**State of New Mexico
General Services Department
Purchasing Division
(505) 827-0472**

Amendment No. **Two**

Re: Invitation to Bid Number: **50-52100-25-06151**

Title: **Madrid Stormwater and Erosion Control Project**

Site Classification is Class C

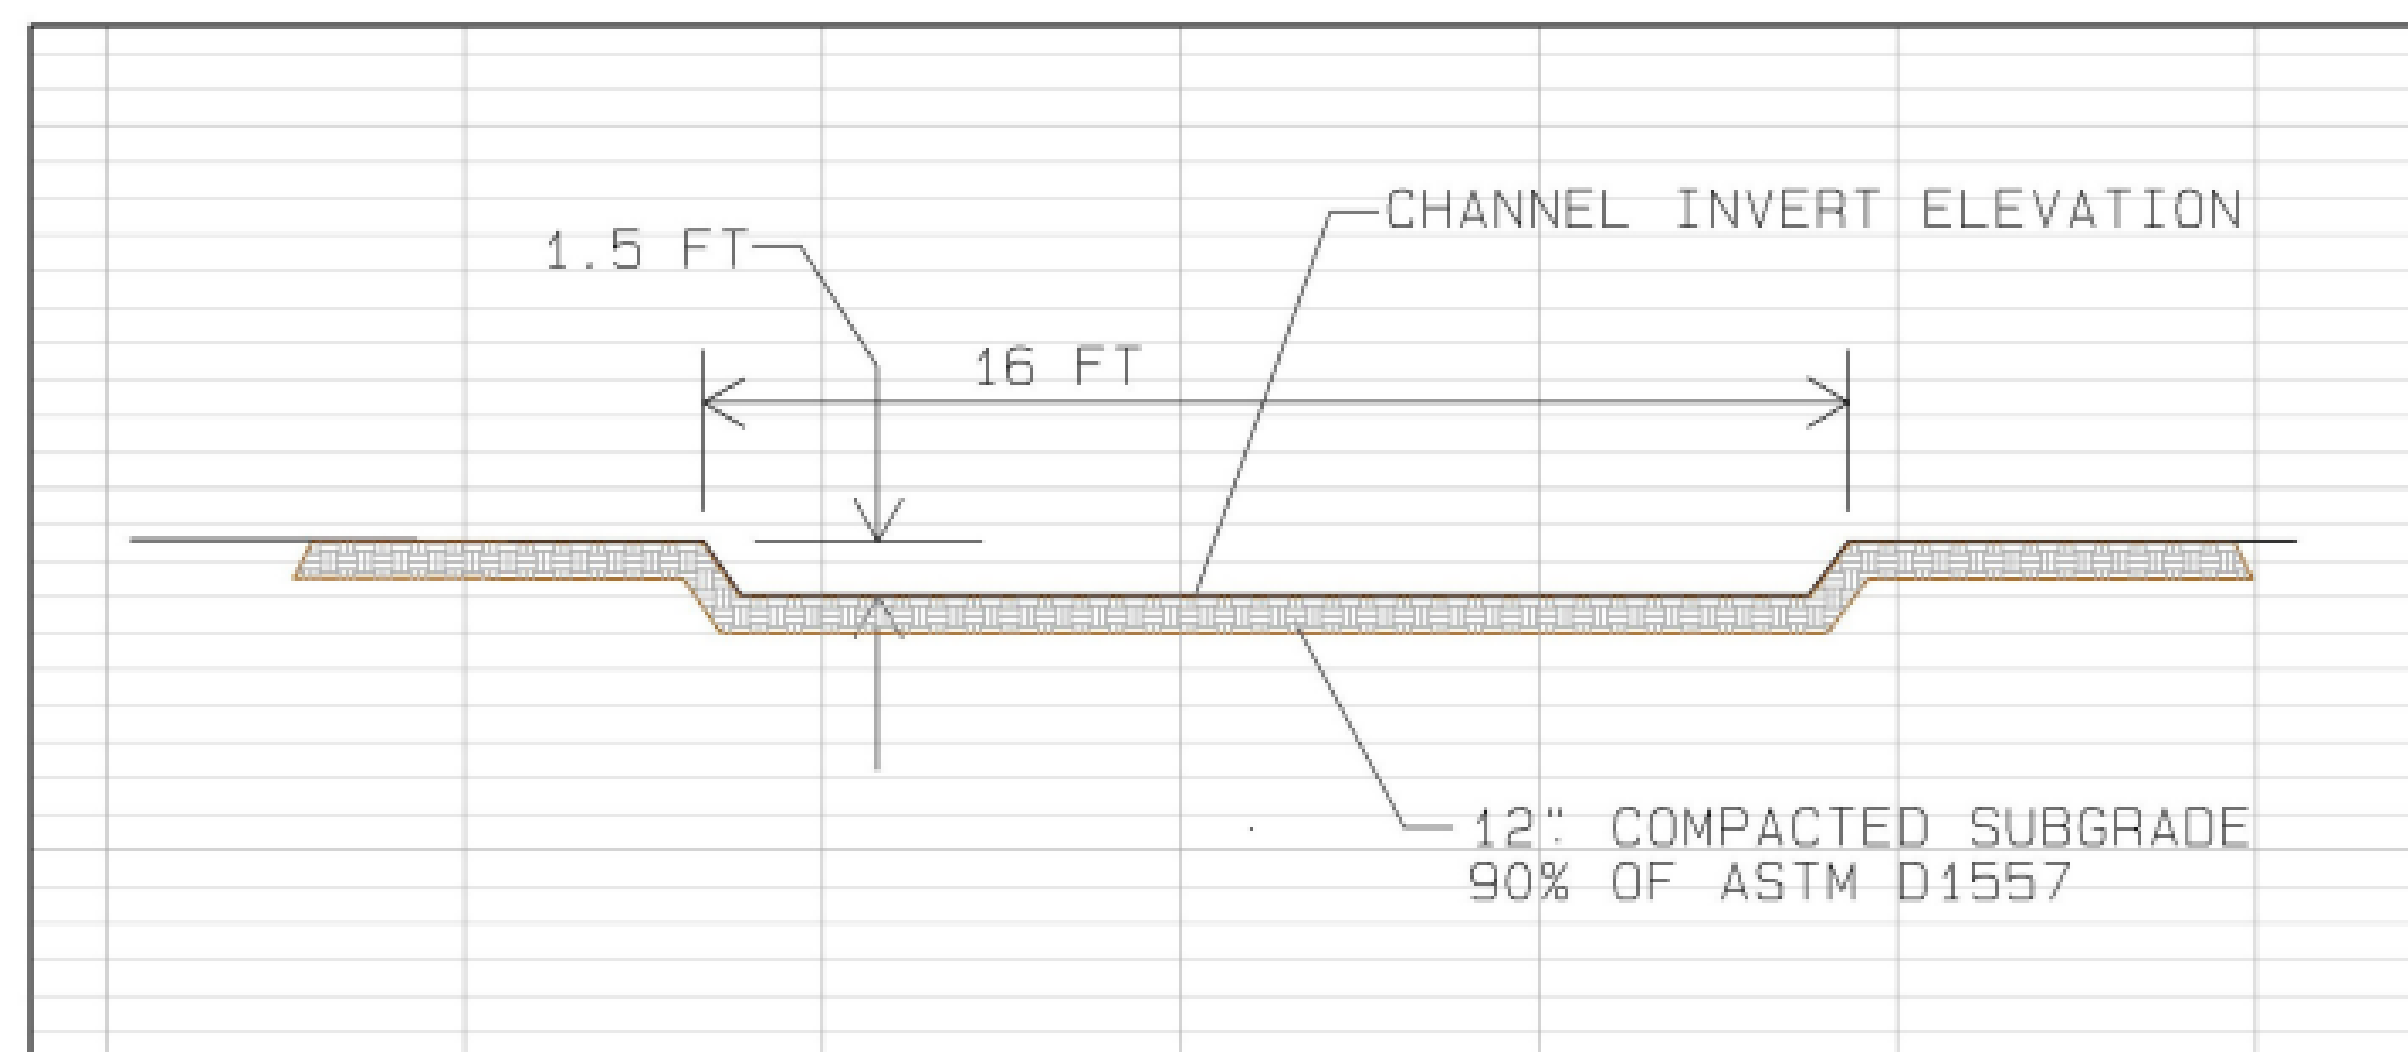
- 5.) **Western Technologies Final Geotechnical Report (66 pages, Attached Below)**
- 6.) **Page C217 on the for-bid drawing set did not print correctly. This page was printed as a duplicate of page C219 on the published version of the bid-set for unknown reasons. Please see the attached sheet as C217 (1 page, Attached Below)**
